AVIAD AIRCRAFT INC

SERVICE LETTER

SUBJECT: Possible damage to turtle deck.

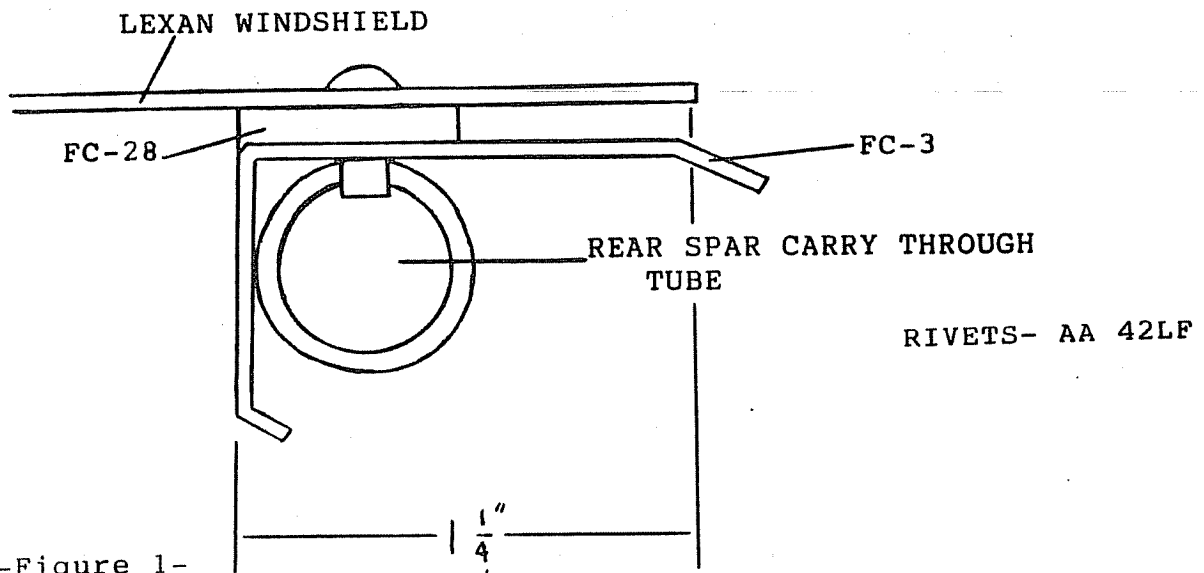
If your skylight has been installed, check to see that the minimum edge distance requirement has been met. If after inspection it is determined that you have inadequate edge distance, refer to Figure 2.

- A. Remove rivets attaching the Lexan to the rear spar carry through tube.
- B. Install an aluminum strip .016-025-thick, between PN FC-28 and the Lexan windshield ensuring a minimum of 1 1/4" length as measured from the front edge of FC 3 to the rear most edge of the aluminum strip.
- C. Install rivets, check turtle deck fit.

-Figure 1-

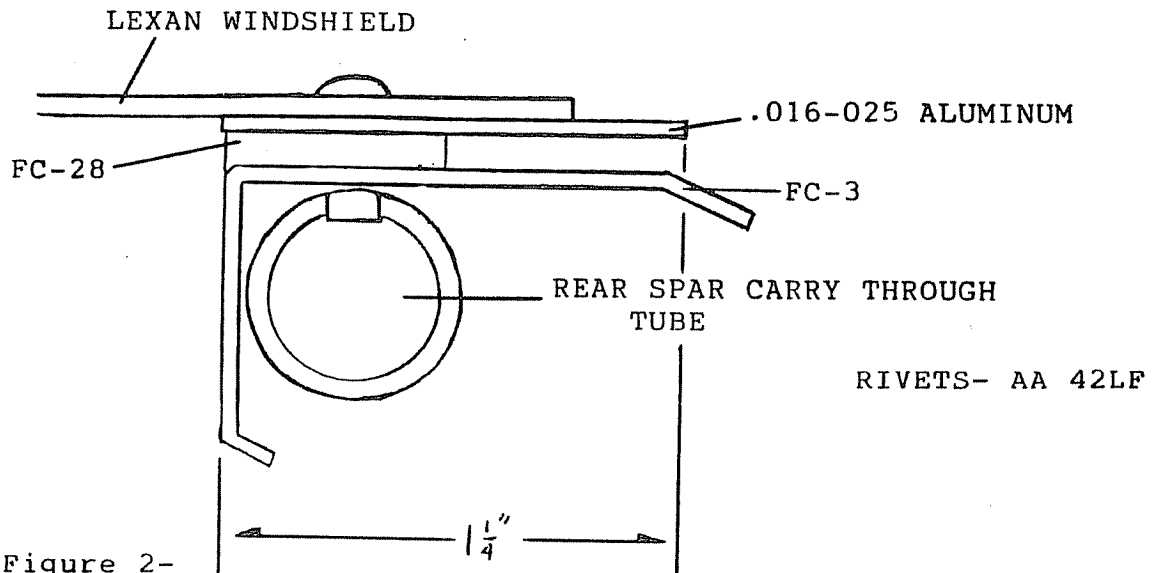
ACTION: If you have not yet installed your skylight, refer to figure 1. Note, the edge distance on the skylight must be at least 1 1/4".

To ensure proper engagement of the turtle deck leading edge under the Lexan skylight, see that a minimum of 1 1/4" of skylight extends off as measured from the front edge at FC 3 to the rear edge of the Lexan.
